SPECIAL BIDS AND AWARDS COMMITTEE (SBAC) FOR NCC ACCESS ROADS

**BIDDING FOR THE CONSTRUCTION OF AIRPORT-NCC ACCESS ROAD (PHASE 1)
BID BULLETIN NO. 2**

This Bid Bulletin clarifies written queries received from prospective bidders until 5:00 PM of May 11, 2018, and other matters relative to the Bidding for the Construction of Airport-NCC Access Road (Phase 1).

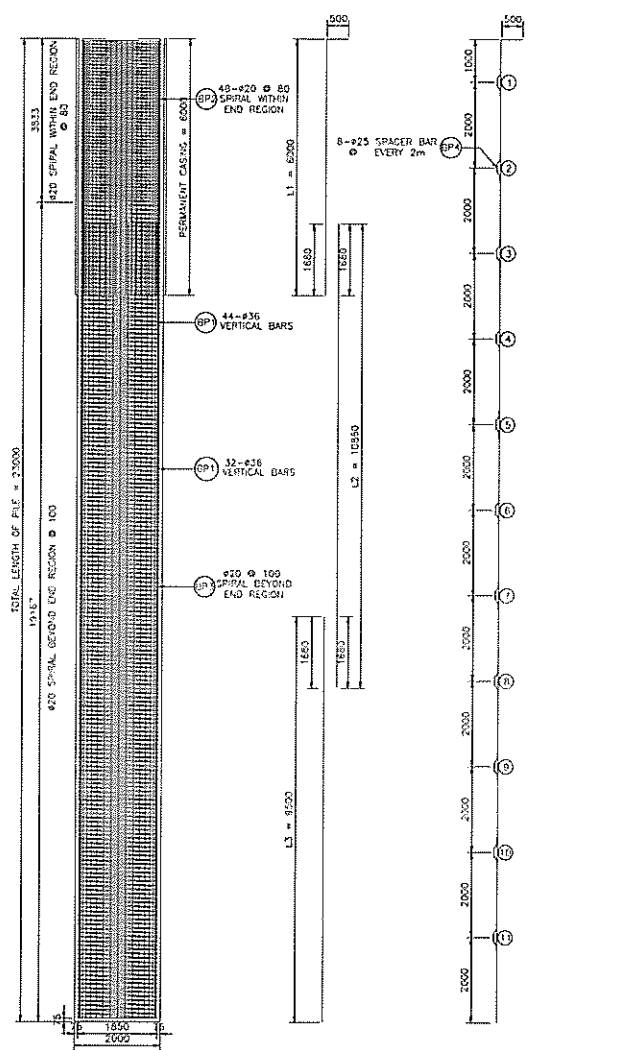
2. May we request information on the river profile of Sacobia Bridge & the two other bridges showing the existing river bed profile including the elevation of the ordinary water level, to be used as basis in the craneway design and general construction methodology for the project.	See attached river bed elevation, ordinary water elevation for Sacobia, Bridge 5 and Bridge 6.

BRIDGE NAME	STATION		LENGTH	WATER LEVEL
	1ST APP	2ND APP	(m)	(m)
Sacobia	0+220.00	1+114.00	894	+0.30
Bridge 5	17+013.35	17+078.95	65.6	+1.00
Bridge 6	19+131.00	19+176.50	45.5	+1.50

* OWL = RBE + WL

SCHEDULE OF REINFORCEMENT FOR PIER 6 BORED PILE

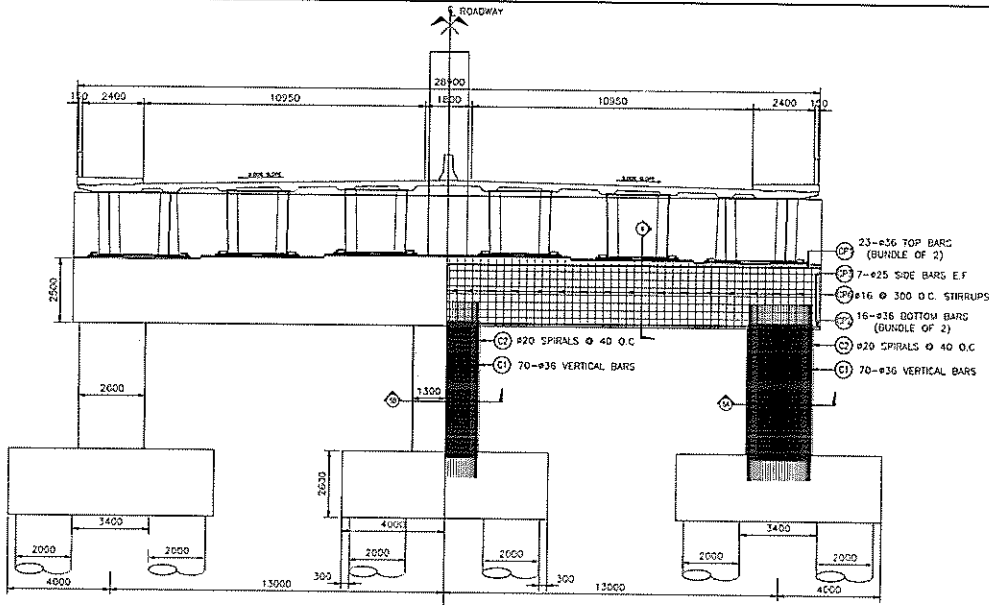
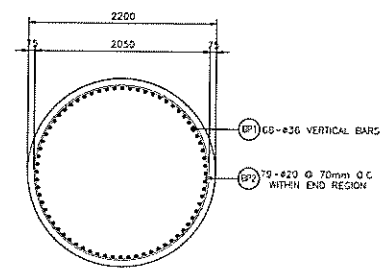
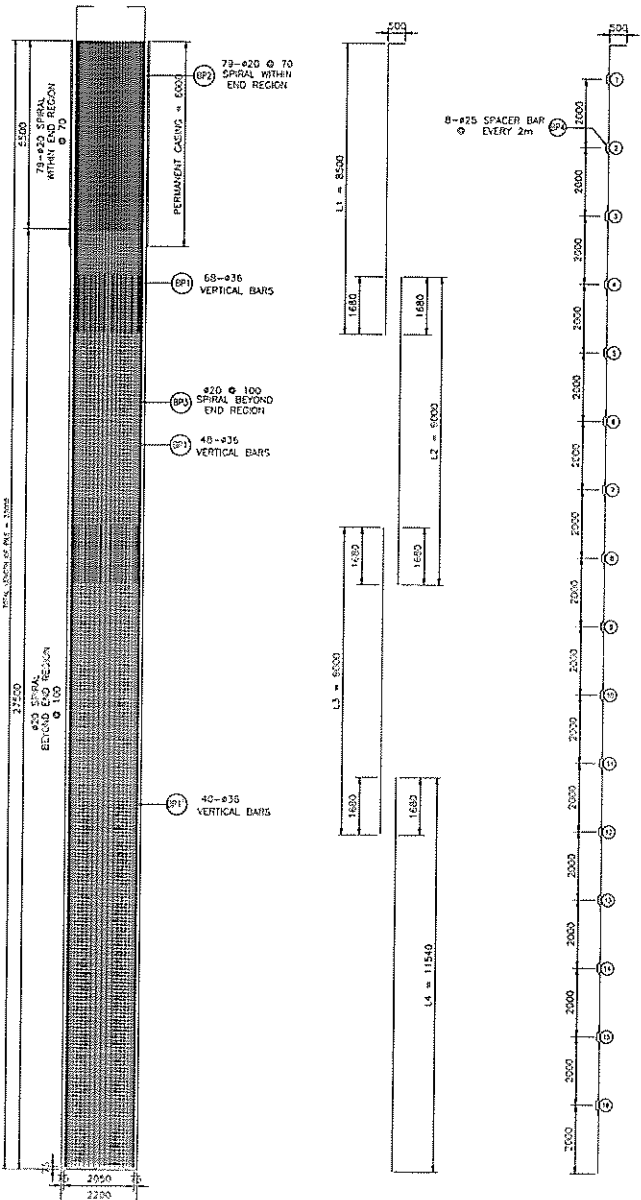
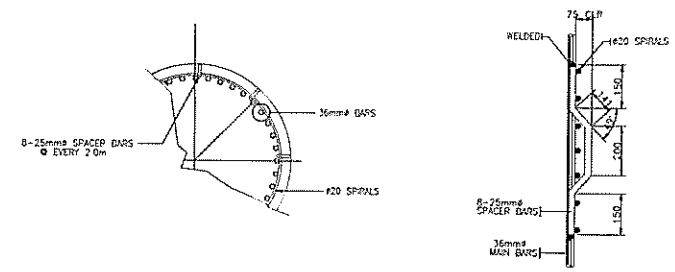
18. Discrepancies on the bored pile reinforcements.	See attached list of correct diameters of bored pile including affected drawings. It can also be downloaded at bcda.gov.ph as attachment to Bid Bulletin No. 2.

Bored Pile Location	Sheet No.	Reference	Qty. of Vertical Reinforcement (PCS)	Qty. of Vertical Reinforcement (PCS) Corrected
Pier 2	P2SB - 40	Detailed Dwg. Sched. Of Reinforcement	BP1 - 44 BP1 - 32	BP1 - 44 BP1 - 44
Pier 6	P2SB - 49	Detailed Dwg. Sched. Of Reinforcement	BP1 - 68; BP1' - 48; BP1" - 40 BP1 - 64; BP1' - 32; BP1" - 64	BP1 - 68; BP1' - 48; BP1" - 40 BP1 - 68; BP1' - 48; BP1" - 40
Pier 7	P2SB - 52	Detailed Dwg. Sched. Of Reinforcement	BP1 - 32; BP1' - 32; BP1" - 32 BP1 - 64; BP1' - 32; BP1" - 64	BP1 - 32; BP1' - 32; BP1" - 32 BP1 - 32; BP1' - 32; BP1" - 32
Pier 8	P2SB - 55	Detailed Dwg. Sched. Of Reinforcement	BP1 - 26; BP1' - 26; BP1" - 26 BP1 - 64; BP1' - 32; BP1" - 64	BP1 - 26; BP1' - 26; BP1" - 26 BP1 - 26; BP1' - 26; BP1" - 26
Pier 9	P2SB - 58	Detailed Dwg. Sched. Of Reinforcement	BP1 - 32; BP1' - 32; BP1" - 32 BP1 - 64; BP1' - 32; BP1" - 64	BP1 - 32; BP1' - 32; BP1" - 32 BP1 - 32; BP1' - 32; BP1" - 32
